BOX HILL/ BOX HILL INDUSTRIAL PRECINCT

Water Cycle Management POST RE-EXHIBITION STRATEGY REPORT

Prepared for:
Department of Planning & Infrastructure

November, 2012

Figure 4.1
Box Hill/ Box Hill Industrial Precinct

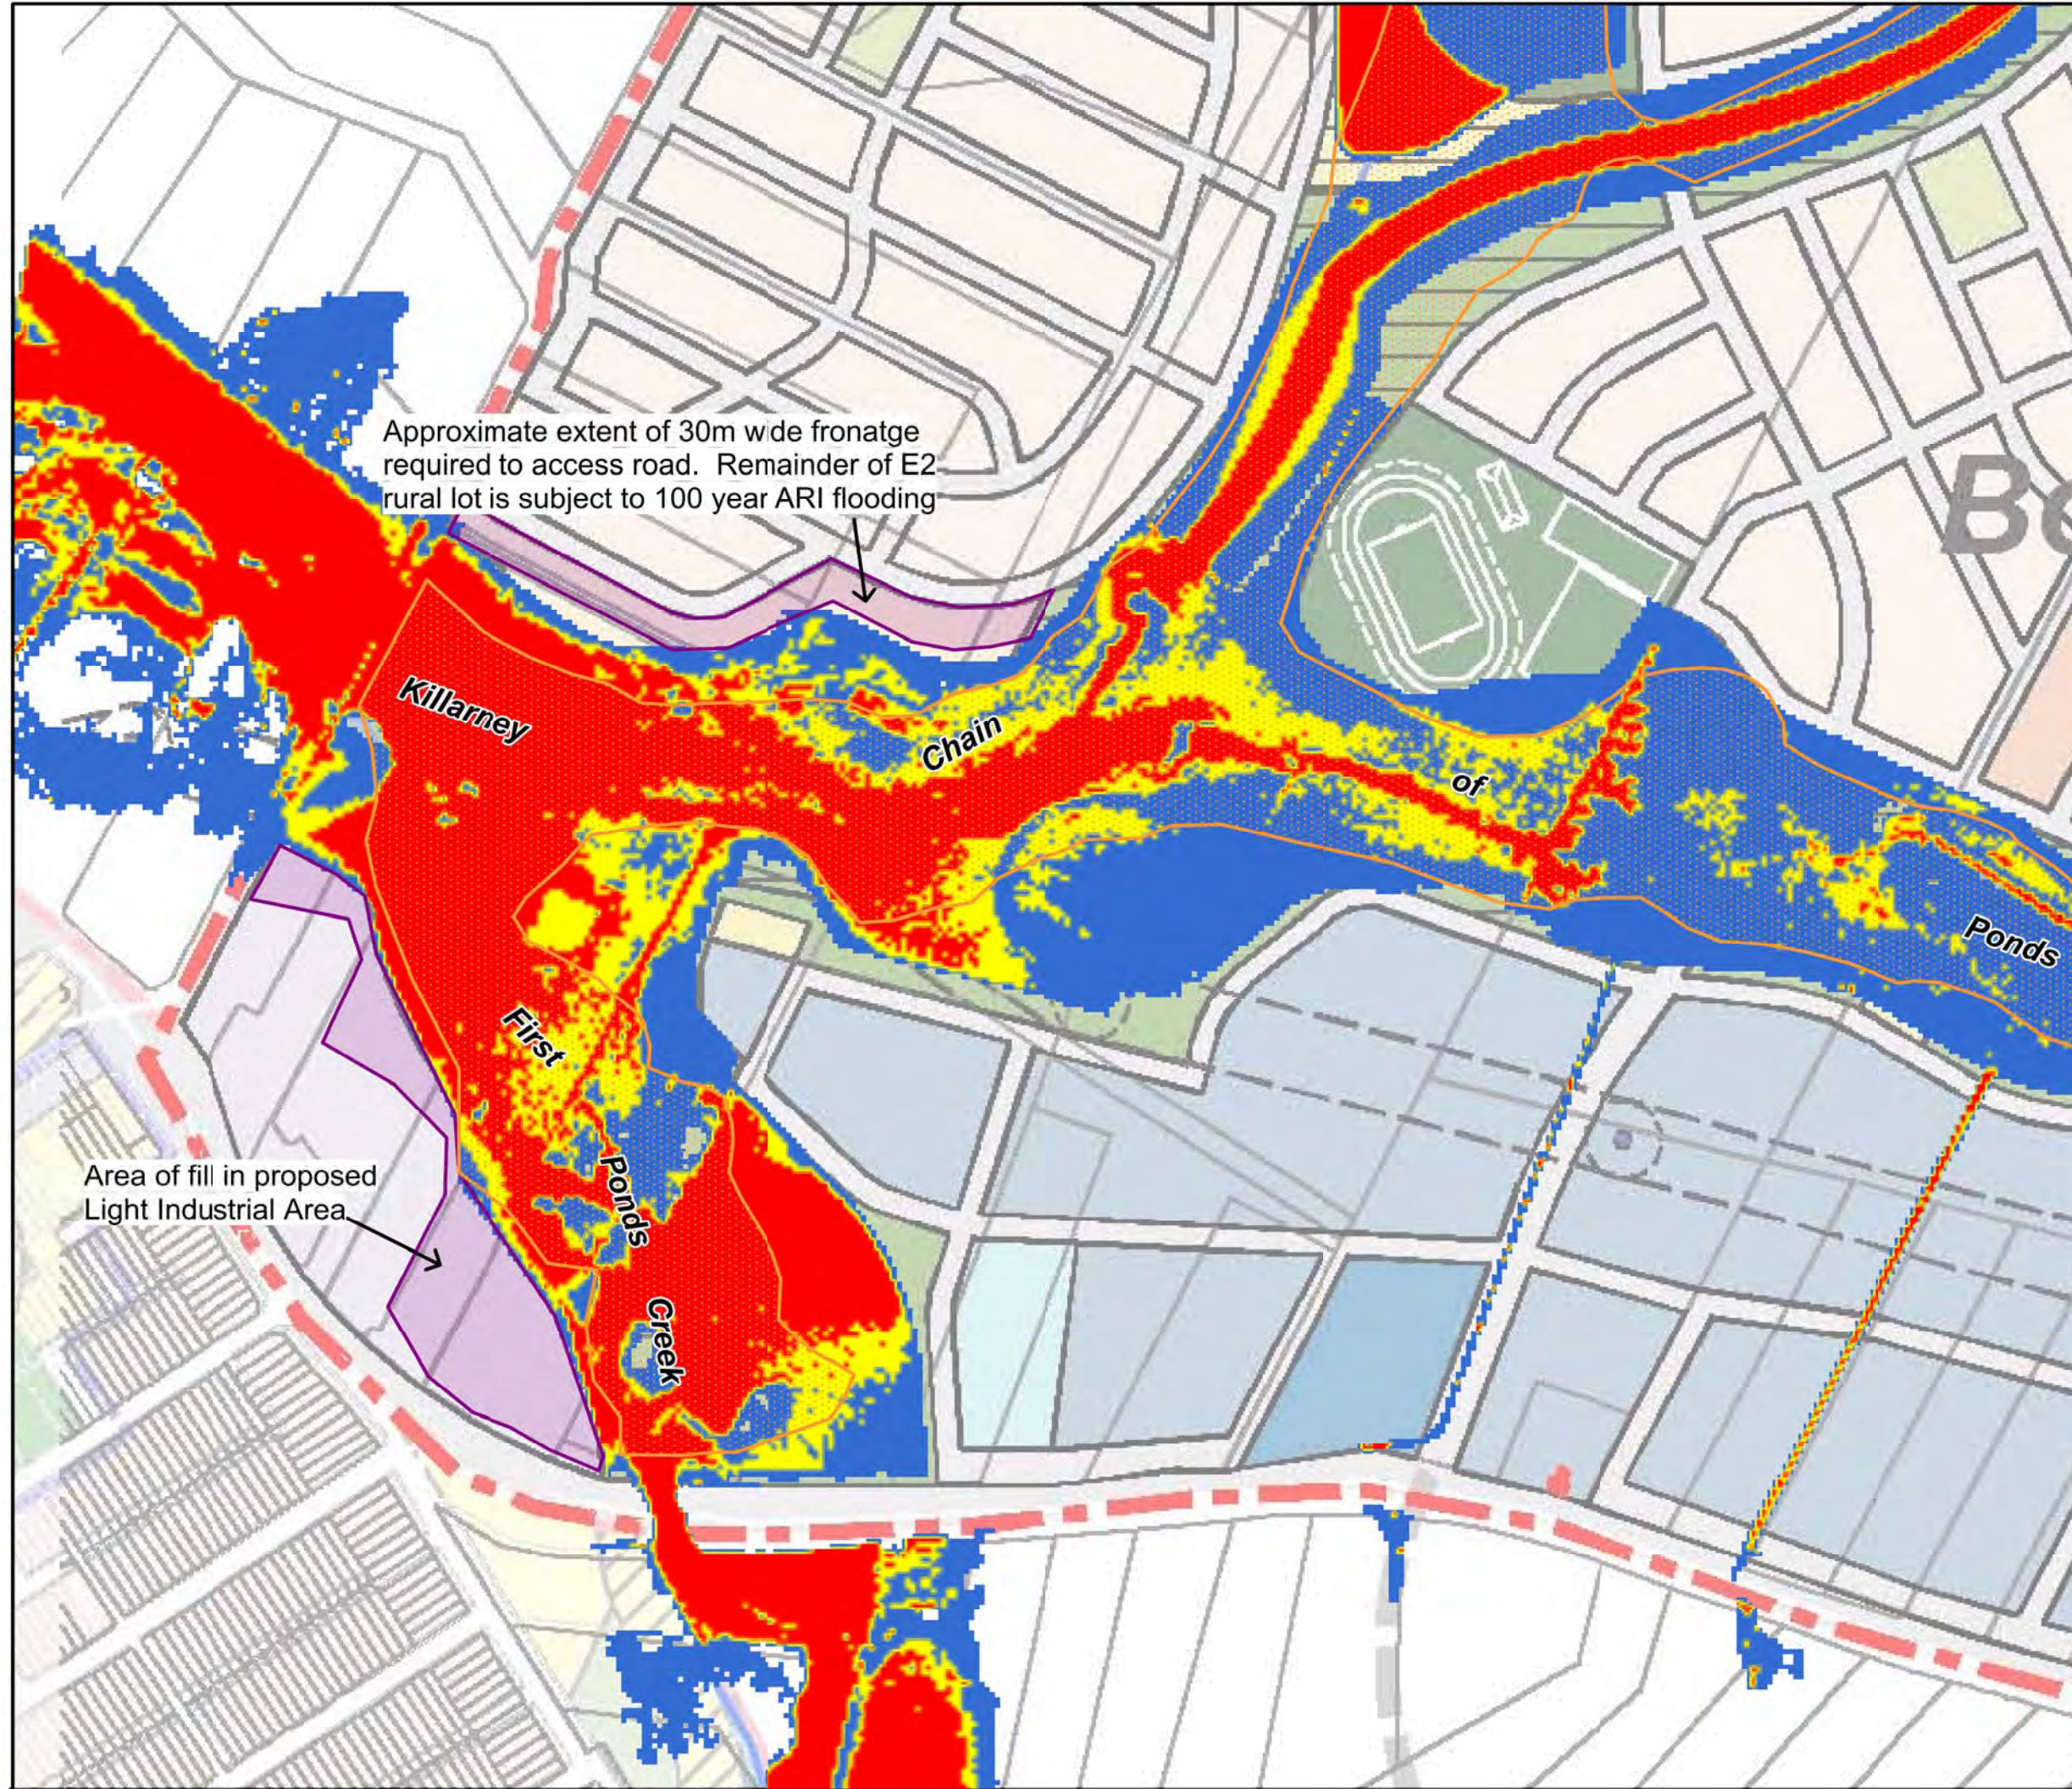
Due to being subject to high hazard categorisation, there are constraints to the developable area available along the eastern bank of First Ponds Creek immediately downstream of Windsor Road (refer to Figure 4.1). The submission indicated that compensatory storage would be required to offset the impact of filling in this area, however, this included cutting out a portion of the proposed light industrial area on the western bank of the development (refer to Figure 4.3).

Notwithstanding this, a significant portion of the area to be reclaimed along the eastern bank of First Ponds Creek, is within an area that has previously been classified as high flood hazard (primarily due to flood depth - refer to Figure 4.2). It is our understanding that parts of the site in this area require approximately one (1) metre of fill to be raised above 100 year ARI flood levels, which is primarily why this land was not considered as a potential development area in the initial planning of the Precinct.

Further refinement of the surface modelling of the road frontages for the rural residential zoned lots in this area by providing minor filling will ensure that there is sufficient pad area (front 30 metres of each lot) for a dwelling and other assets above the design 100 year ARI flood event. The assessment undertaken indicates that the required additional filling will have negligible impact on flooding through the site (refer to Figure 4.1).

Figure 4.4
Box Hill/Box Hill Industrial Precinct

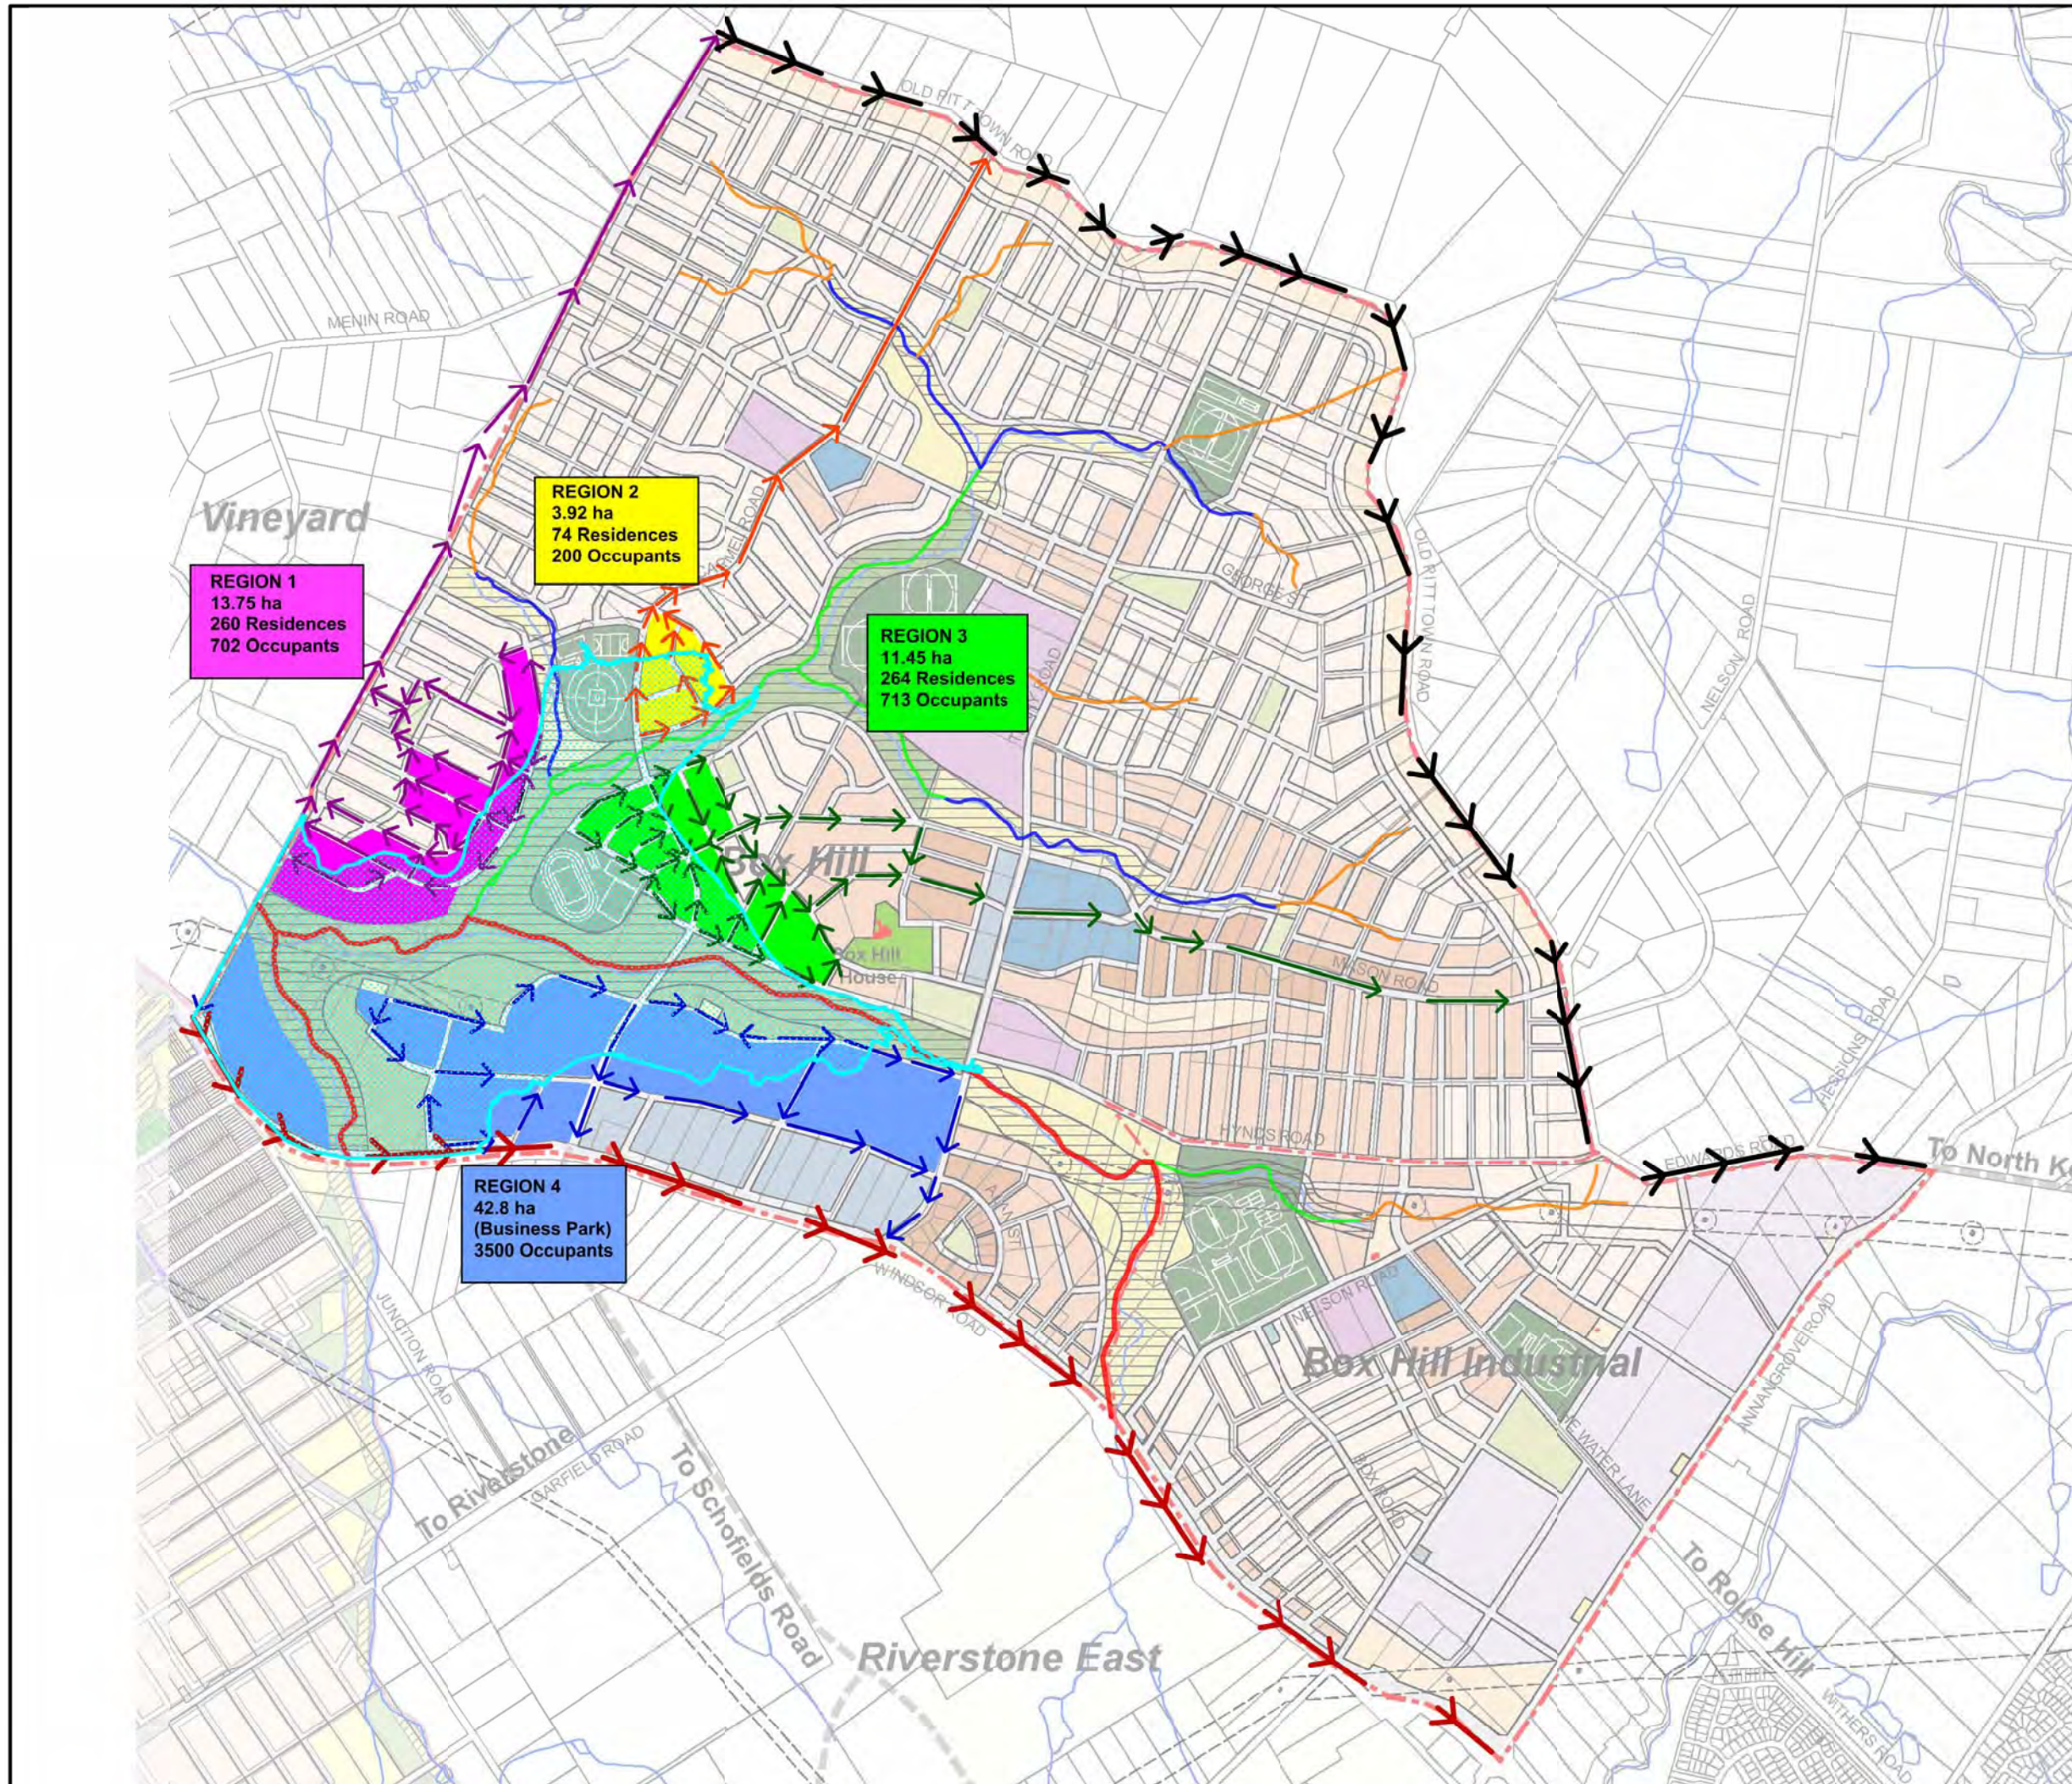
Regarding emergency flood evacuation, OEH also recommended:

- Consultation with the SES in the early stages of the planning process, due to the complex evacuation strategies throughout the Precinct;
- Option of evacuating locally to a refuge on-site within the higher closer ground above the regional PMF in consultation with the SES;

- Consideration of local catchment flooding coinciding with regional Hawkesbury/Nepean PMF flooding where local roads/access can be cut by localised flooding preventing safe evacuation; and
- Further consultation with the SES regarding the proposed strategy to “shelter in place” or relocate to higher ground within the Precinct for the local PMF flood event.

The evacuation plan previously presented in the original Water Cycle Management strategy report has now been updated to comply with the latest ILP, refer to Figure 4.4 for the updated evacuation plan.

The safe evacuation of residents during extreme flood events will need to be further assessed as part of any development application for land that is within the regional PMF extent as shown in Figure 4.4 of this report.
